# Work Order ID 103445

Item Name: Replacement Exterior Window for -111

### D3290-041 REPLACEMENT WINDOW ASSEMBLY

DRAWING NO. D3290	TITLE REPLACEMENT WINDOW ASSEMBLY	REV. C	DART AEROSPACE LTD ENGINEERING ORDER		D.E.O. NO. D3290-C-1	SHEET NO. SHEET 1 OF 1	SCALE NTS
DRAWN <i>qp</i>	CHECKED <i>ls</i>	MFG. APPR. <i>EZ</i>	APPROVED <i>MP</i>	DE APPR. <i>#1</i>			
DATE 09.09.18	DATE 09.09.18	DATE 09.09.18	DATE 09/09/21	DATE 09/09/21

### D3290-1 FRAME

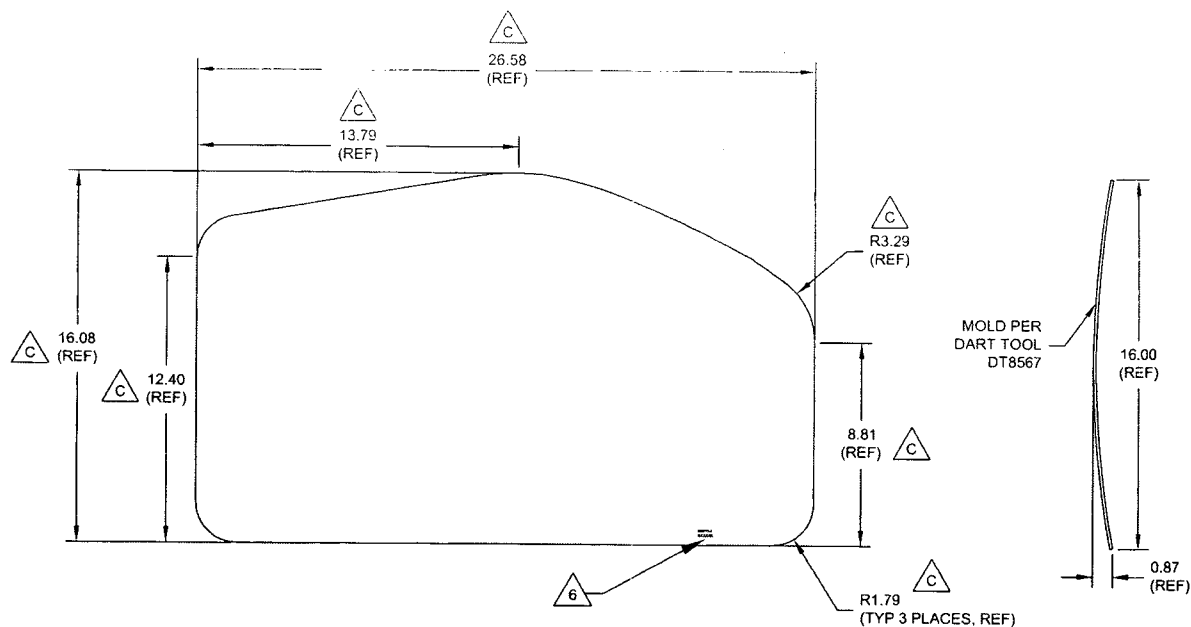
CHANGE MATERIAL THICKNESS OF D3290-1 FRAME TO 0.063 FROM 0.040. REF PAR 09-033.

MATERIAL CALL-OUT OF D3290-1 FRAME ON SHEET 1 IS AMENDED AS FOLLOWS:

- 1) MATERIAL: 6061-T6 (OR 6061-T62) ALUMINUM SHEET ~~0.040 THICK~~ 0.063 THICK (REPLACE)  
PER AMS-QQ-A-250/11 OR AMS 4025 OR AMS 4027  
~~(REF. DART SPEC. M6061T6S.040)~~ REF. DART SPEC. M6061T6S.063 (REPLACE)  
OR  
5052-H32 ALUMINUM SHEET ~~0.040 THICK~~ 0.063 THICK (REPLACE)  
PER AMS-QQ-A-250/8 OR AMS 4016  
~~(REF. DART SPEC. M5052H32S.040)~~ REF. DART SPEC. M5052H32S.063 (REPLACE)
